GARMIN G1000 GPS/WAAS INSTALLATION

This modification kit provides instructions and parts to install the global positioning system (GPS)/ wide area augmentation system (WAAS) option.

SB07-34-07

December 3, 2007

Figure 1. 172 Antenna Installation for WAAS (Sheet 1)

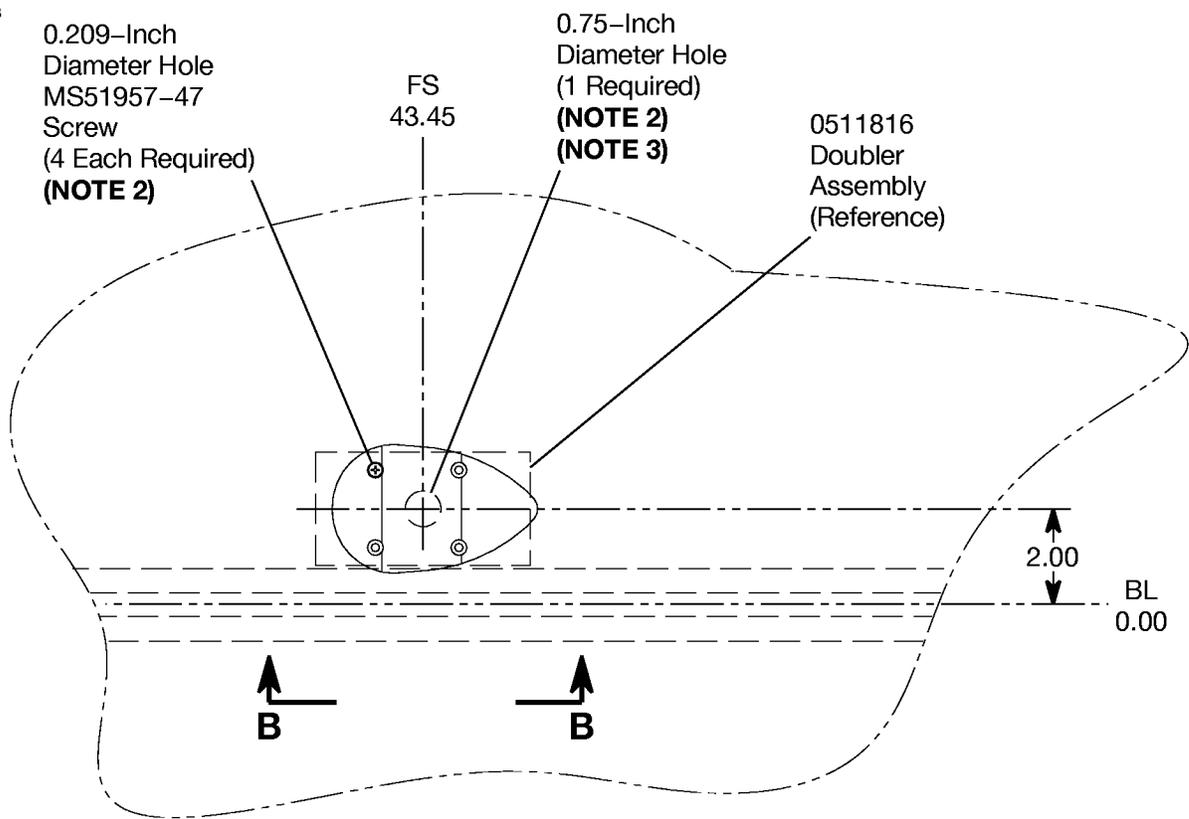
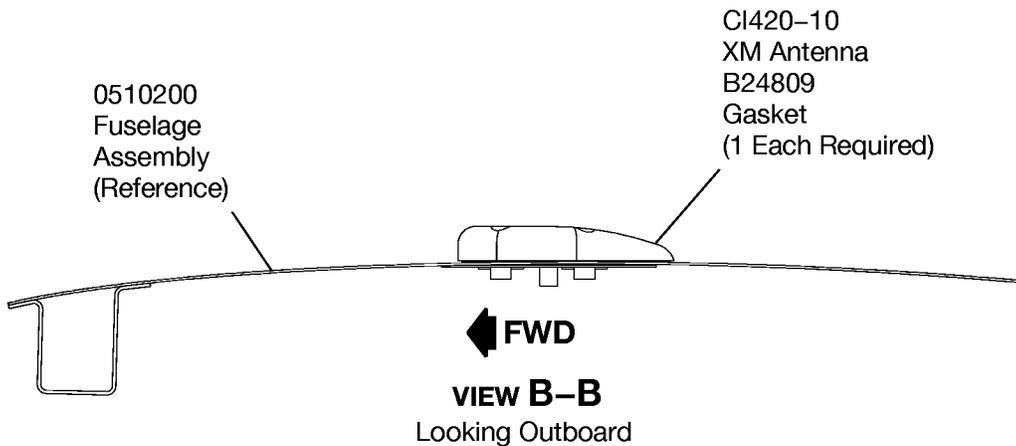
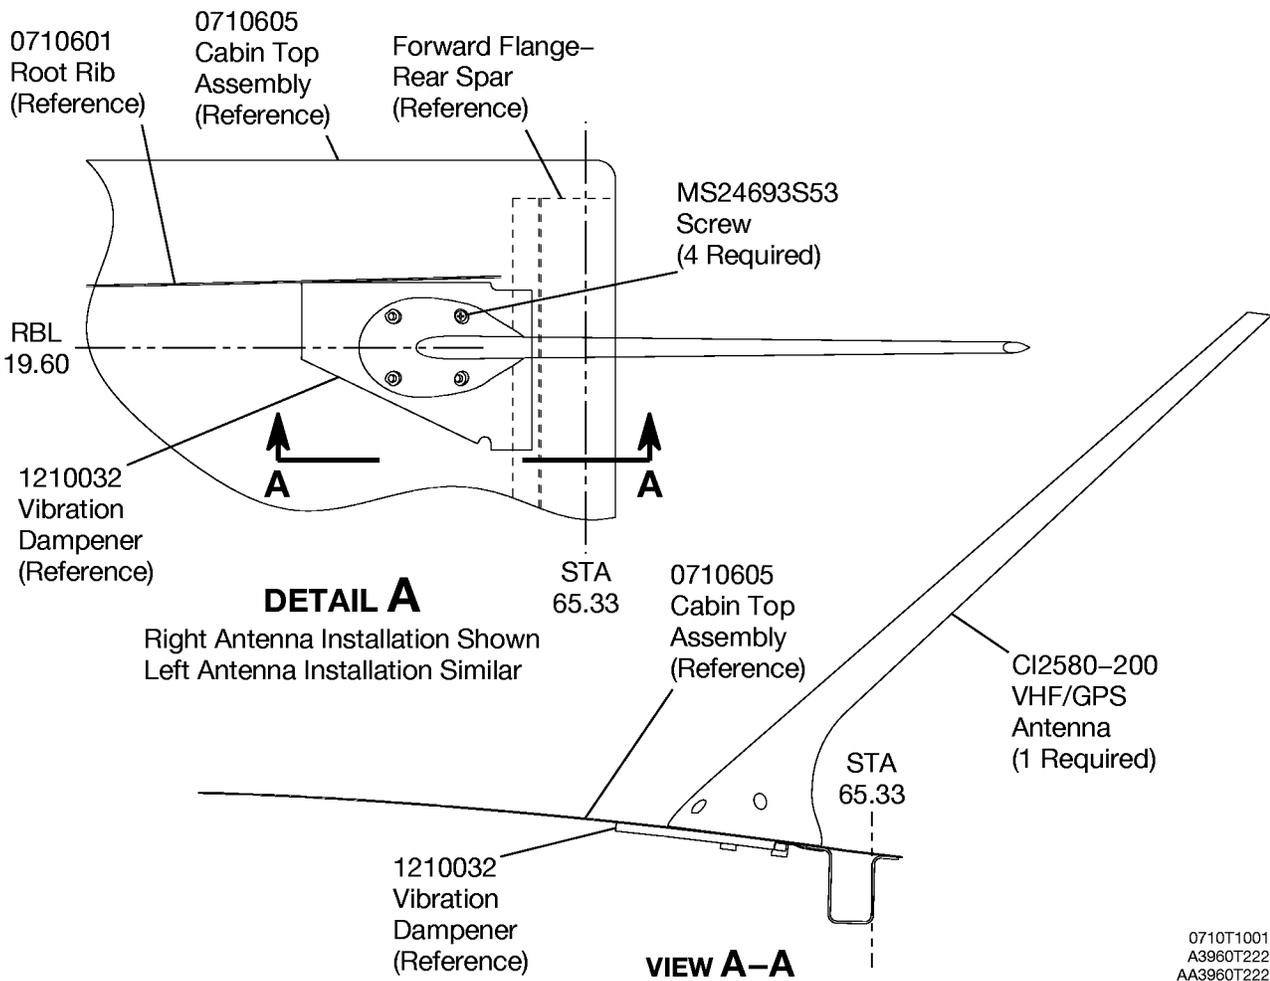
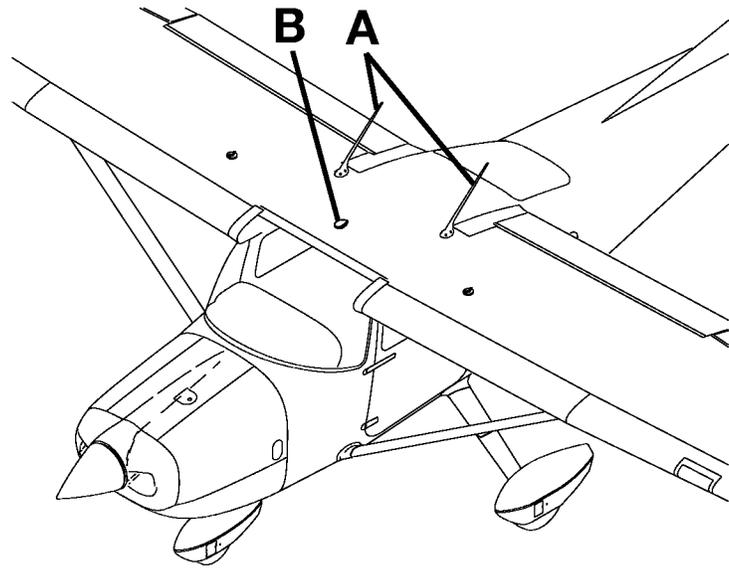
13. Apply U060031 Sealant in one continuous bead all around the bottom surfaces of the two CI2580-200 VHF/GPS Antennas.
 14. (Refer to Figure 1, Detail A and View A-A (172), Figure 2, Detail A and View A-A (182), or Figure 3, Detail A and View A-A (206).) With the eight MS24693S53 Screws and the installed cable assembly connectors, install two CI2580-200 VHF/GPS Antennas in the positions where you removed the CI2480-200 VHF/GPS Antenna #1 and the CI2480-400 (CI2480-200 for airplanes not equipped with the GDL-69A Data Link Unit) VHF/GPS/XM Antenna #2. Do not apply sealant on top of the antenna mounting screws. (Refer to the applicable maintenance manual, Chapter 23, Communications - Maintenance Practices.)

15. (Airplanes equipped with the GDL-69A Data Link Unit and Autopilot) (Refer to Figure 1, Detail B and View B-B (172), Figure 2, Detail B and View B-B (182), or Figure 3, Detail B and View B-B (206).) Install the CI420-10 XM Antenna as follows:

- A. Find the factory-installed 0511816 Doubler for the CI420-10 XM Antenna.
 - B. Use the hole in the center of the 0511816 Doubler to match drill one 0.75-inch diameter hole through the airplane skin.

- C. If there is not sufficient clearance for the CI420-10 XM Antenna, remove a maximum of 0.25 inch of the material aft of the drilled 0.75-inch diameter hole to get clearance.

- D. From the airplane interior, use the four nutplate holes (for the MS51957-47 Screws) in the 0511816 Doubler to match drill the four holes to Number 40 (0.098-inch diameter) holes.

- E. From the airplane exterior, match drill the four Number 40 (0.098-inch diameter) holes to four 0.209-inch diameter holes.
 - F. Deburr the holes and apply Alodine to bare metal.

Figure 4. Cable Assembly (Sheet 1)

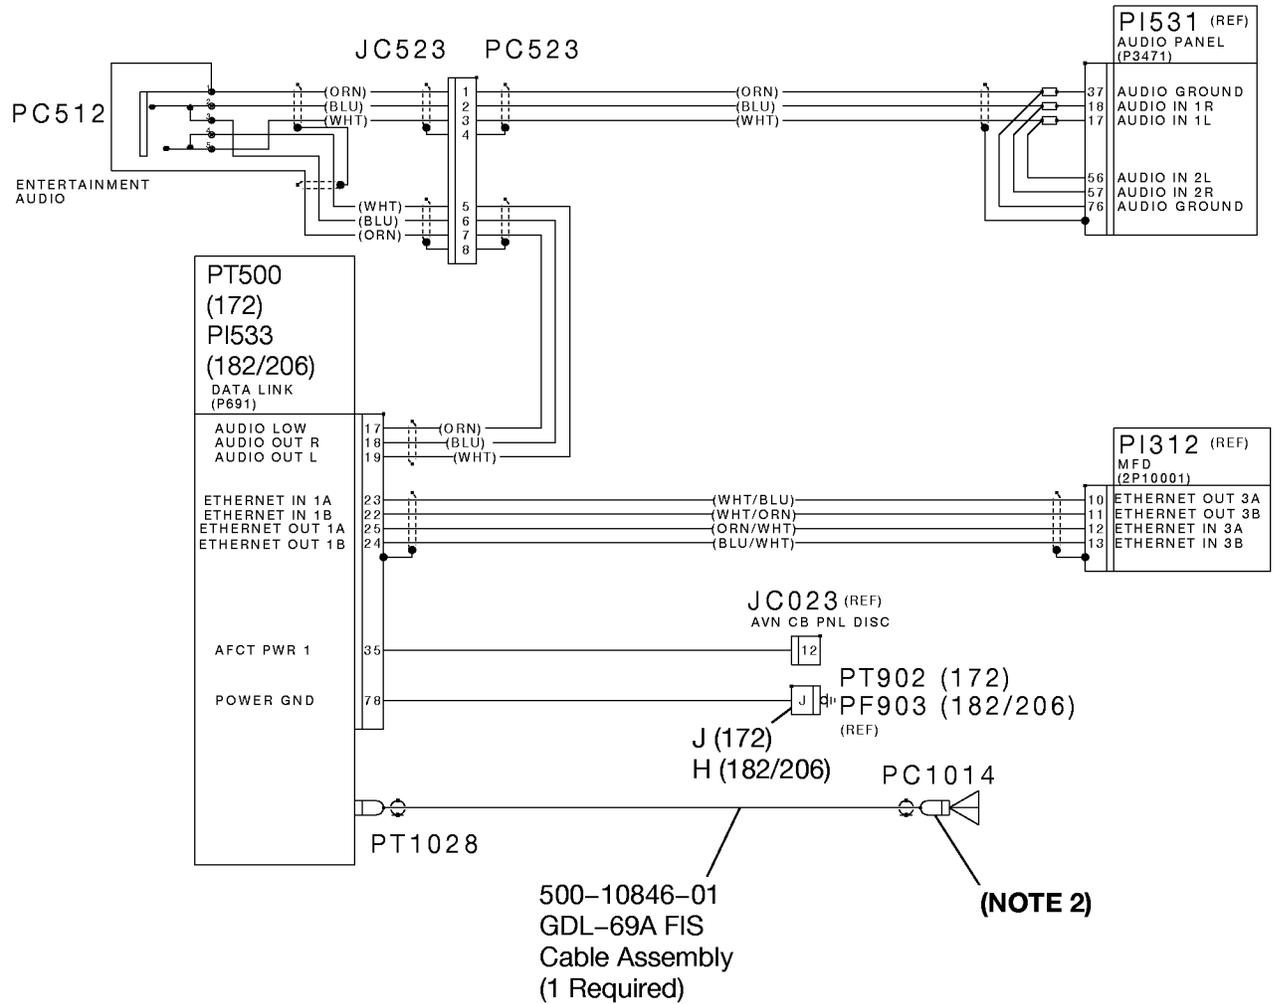
3. (Refer to Figure 4.) Remove and discard the two CI511 Attenuators and the two short coaxials (PT1012-PT1025 and PT1017-PT1027) that are installed on the GPS 1 coaxial at the GIA-63 Integrated Avionics Unit and the GPS 2 coaxial at the GIA-63 Integrated Avionics Unit.

6. (Refer to Figure 4.) Remove the installed GPS 1 coaxial connector that connects to the 011-01105-00 Garmin GIA-63 Integrated Avionics Units.
 7. Remove the installed GPS 2 coaxial connector that connects to the 011-01105-00 Garmin GIA-63 Integrated Avionics Units.

NOTE 1: Remove and discard the two CI511 Attenuators and the two attached coaxials (PT1012–PT1025 and PF1017–PT1027). They are installed no more than 6 inches from the GIA–63 dual–integrated avionics units.

Figure 4. Cable Assembly (Sheet 2)

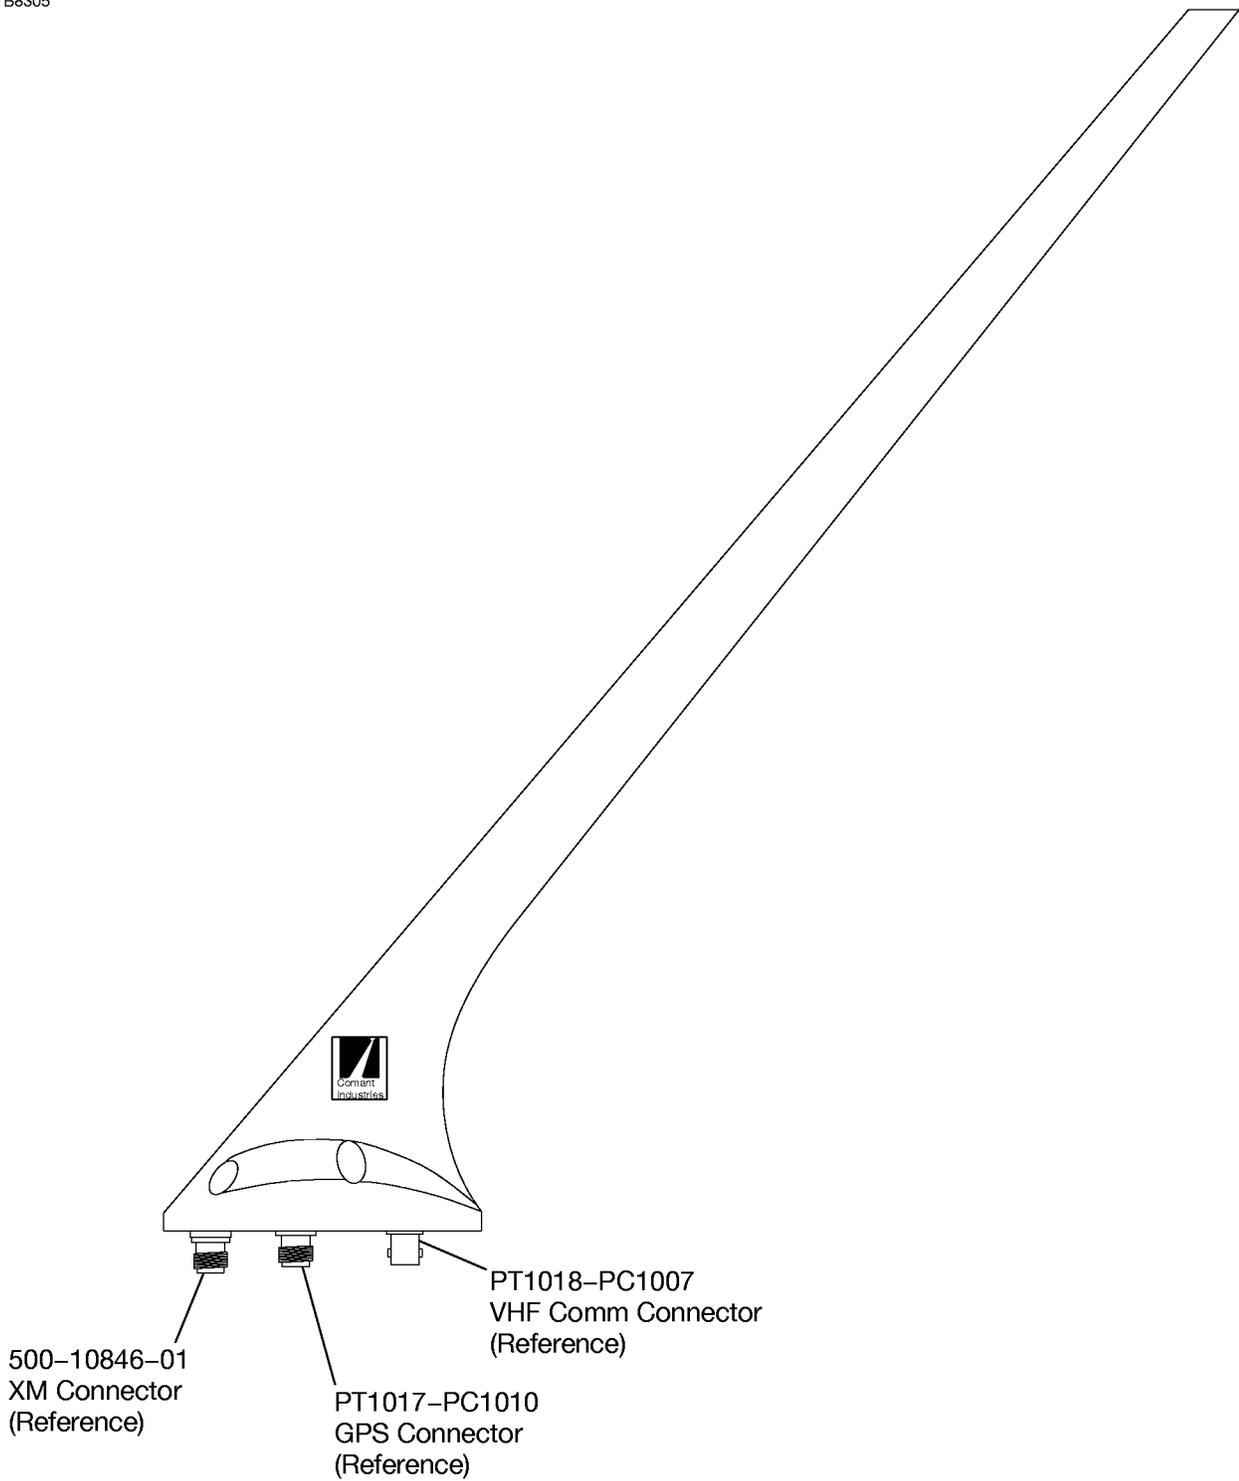
19. (Airplanes equipped with the GDL-69A Data Link Unit and an Autopilot) (Refer to Figure 4, Sheet 2.) Install one 500-10846-01 GDL-69A FIS Cable Assembly as follows:

- A. Remove interior and exterior access panels as necessary to get access to do the routing of the 500-10846-01 GDL-69A FIS Cable Assembly.
 - B. Connect the red-band end of the 500-10846-01 GDL-69A FIS Cable Assembly to the CI420-10 XM Antenna.

- C. Do the routing of the 500-10846-01 GDL-69A FIS Cable Assembly from the CI420-10 XM Antenna to the GDL-69A line replacement unit (LRU) rack mount. Use the same route as the old CI2480-400 VHF/GPS/XM Antenna #2 cable assembly used.
